Subject: 2011-08-08 Woodlan, Luminant Slides for 8-17-2011 ACRS Subcommittee re
CPNPP Ch 8 and 10
Sent Date: 8/8/2011 12:43:50 PM
Received Date: 8/8/2011 12:46:48 PM
From: Woodlan, Don

Comanche Peak Nuclear Power Plant, Units 3 and 4

ACRS US-APWR Subcommittee

FSAR Chapter 8 – Electric Power

08.01-1 Sharing of SSCs (Open Item)

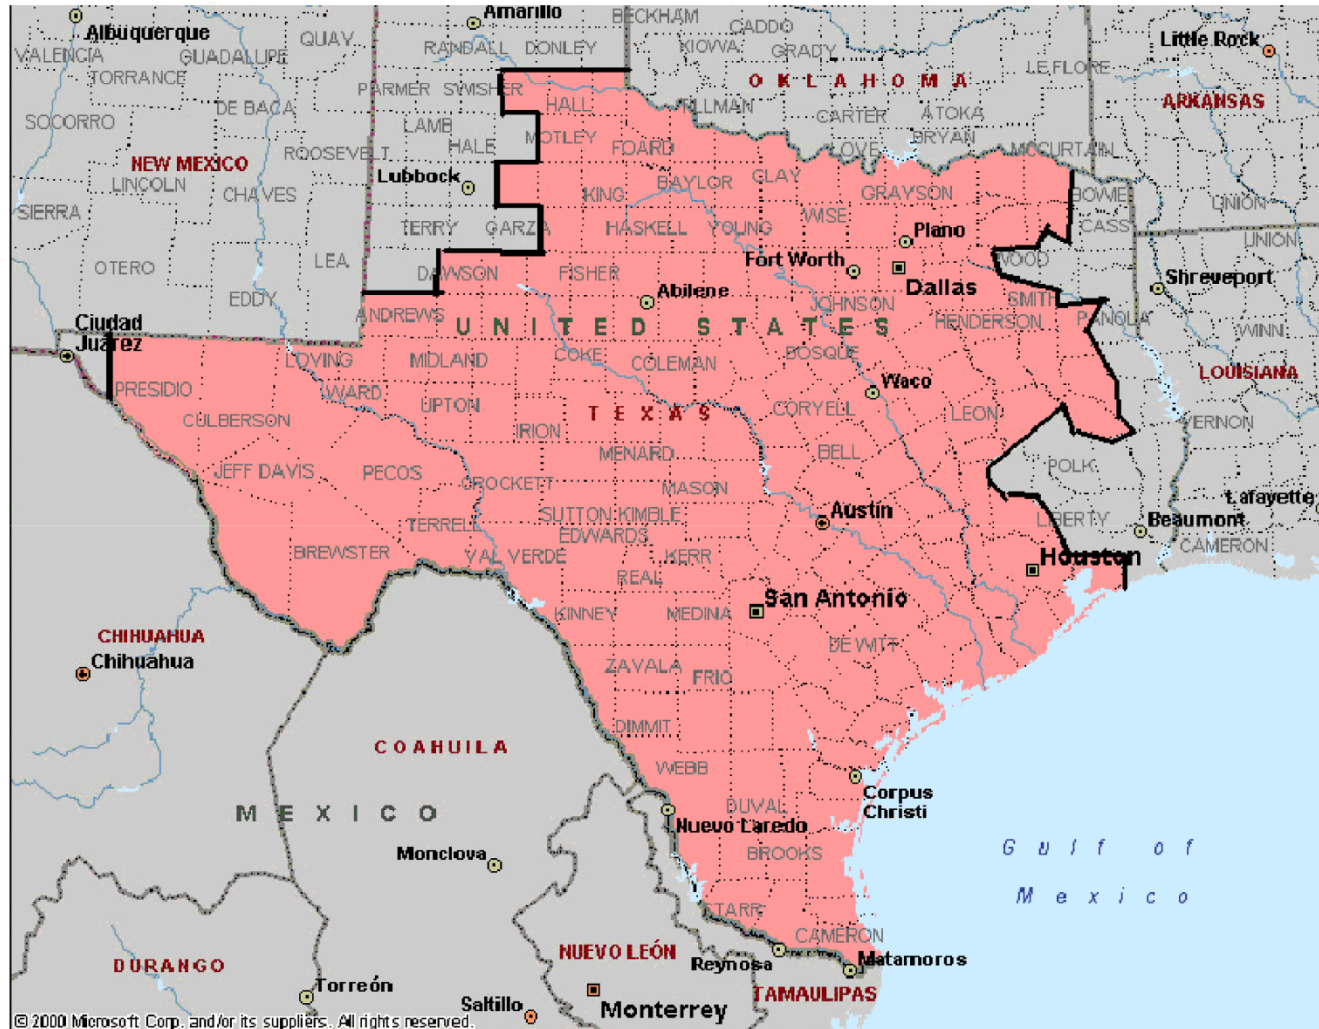
- ❑ **Open Item 08.01-1 related to CP RAI 9 (RAI 2576) Question 08.01-2**
 - **“However, the applicant has not demonstrated whether or not the SSCs important to safety that are shared among nuclear power units will not significantly impair their ability to perform their safety functions, including an accident in one unit, and orderly shutdown and cooldown of the remaining units.”**
 - **Luminant has recently submitted supplemental information to address this Open Item and the response is under NRC Staff review.**
